SS 705-WST 2021 49X XMC3 & XMC4 Output Reliability

49X vehicles built with XMC3 & XMC4

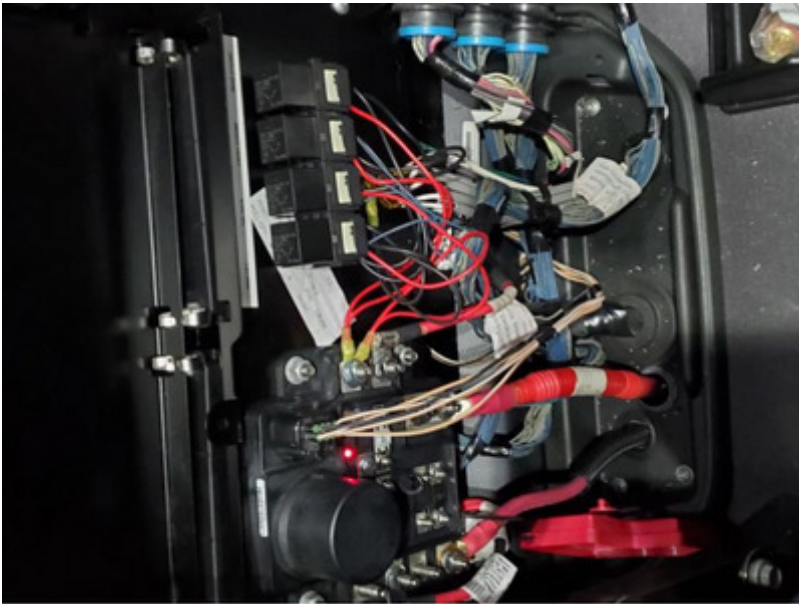
Reliability issue with the six 20 Amp outputs (D01-D06) on the XMC's

For Western Star 49X trucks that implement XMC3 and XMC4, there is more than one way to take advantage of the flexible programming capabilities, using the CHEC tool to program existing XMC's 3 & 4 in the field. For reference, to output names and wiring on Western Star 49X wiring, refer to PartsPro subgroup 35M per serial number.

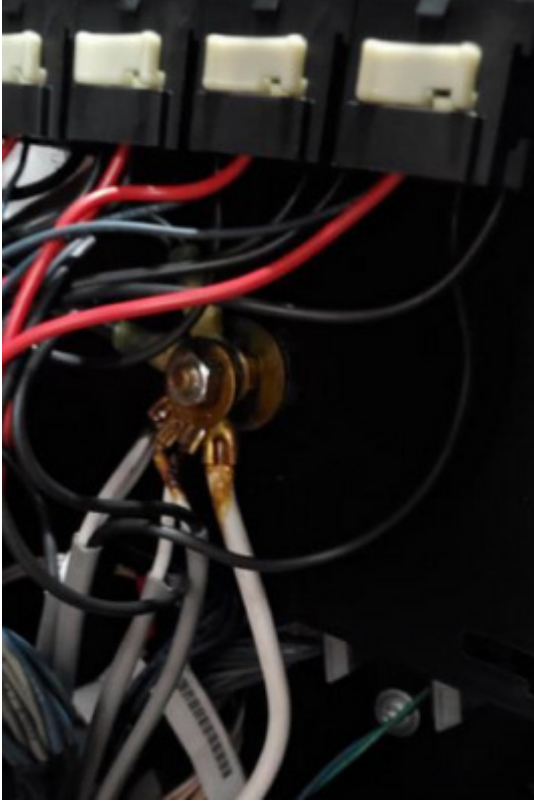
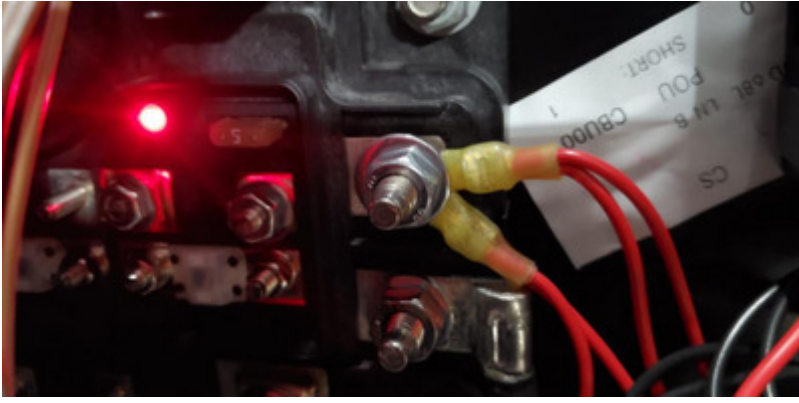
On the XMC3 and XMC4, there are four 5 Amp outputs (D07-D10), and eight 2 Amp outputs (D11-D17). All of the 5 and 2 Amp outputs are working reliably on XMC's. If your current requirements do not exceed these ratings, you can freely program the XMC3 and XMC4 for your purposes and connect to the output pins.

Applications that require higher current capacity may use any of the 2 or 5 Amp outputs to trigger relays to source higher current. There is the option of adding relays individually on a 49X or you can choose the process noted in the paragraph below. Referring to schematic G66-17097-002 (see attached document) in PartsPro module 35M for sample truck S/N MS2152 will provide useful diagrams to implement relays.

There is a released sales code as a viable factory option for higher current applications. It uses 2 Amp outputs to control relays. Sales code 35M-012 (refer to truck S/N MS2152 for wiring information) provides eight 20 Amp, relay driven circuits. Modifying trucks to this sales code provides a feature documented and supported by DTNA. To implement a new sales code on an existing Western Star, follow Service Bulletin 00-004 to submit the truck and desired features to the Modifications department.

Do not use sales code 35M-011 as a solution, the 20A relay circuits in that configuration use the same 20A outputs that are currently failing as the trigger for the relays.
